REMARKS

AMENDMENTS TO THE DRAWINGS

FIG. 2

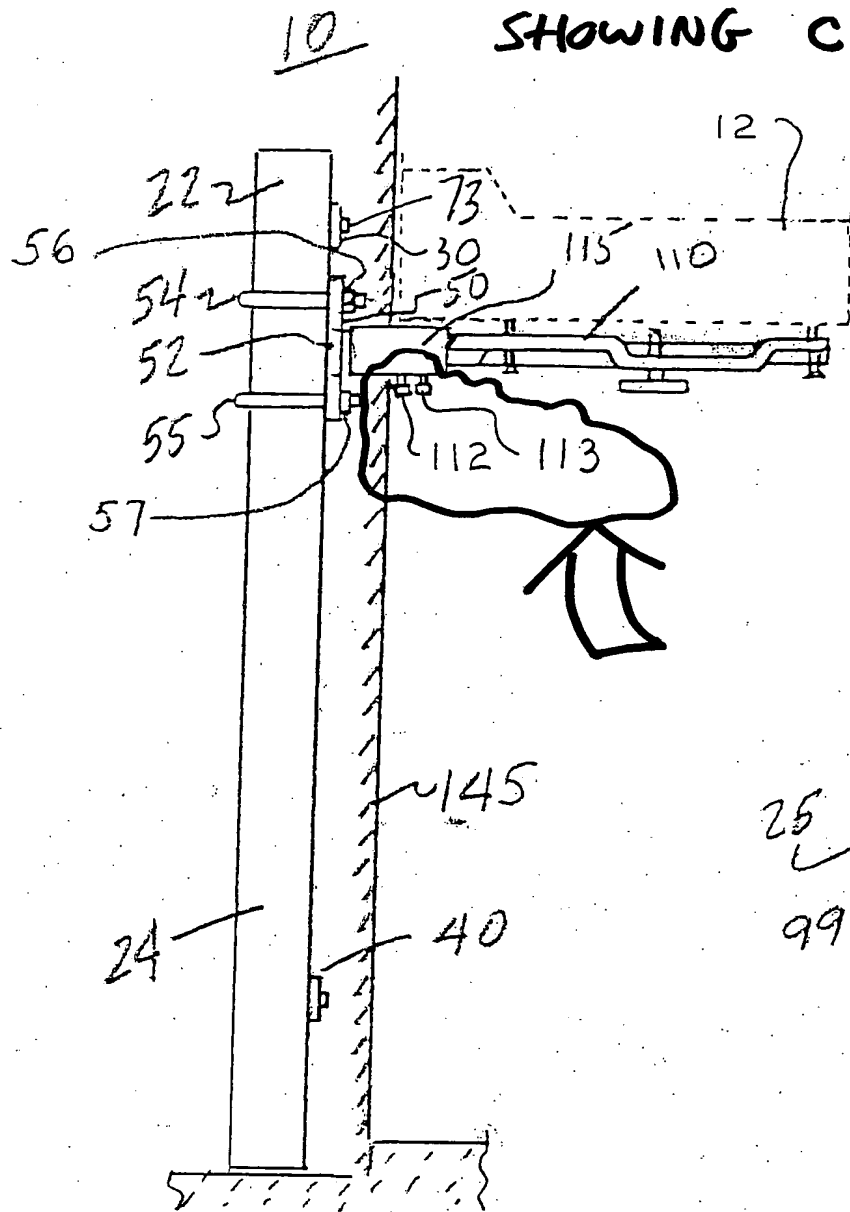
Paragraph [0034] has been amended to specify that sleeves 115 extend through the apertures within the wall as highlighted in Fig. 2. Additionally the arms 110 are locked within the sleeves 115 with locking screws 112, 113 which are also illustrated in Fig. 2.

The attached sheet of drawings includes changes to Fig. 2. The sheet which includes Figs. 2, 3, 4 and 5, replaces the original sheet including Figs. 2, 3, 4 and 5. In particular, reference numbers 112 and 113 have been added. Changes incorporated on this sheet are highlighted on the attached, annotated copy. No new matter is believed to have been added by this amendment.
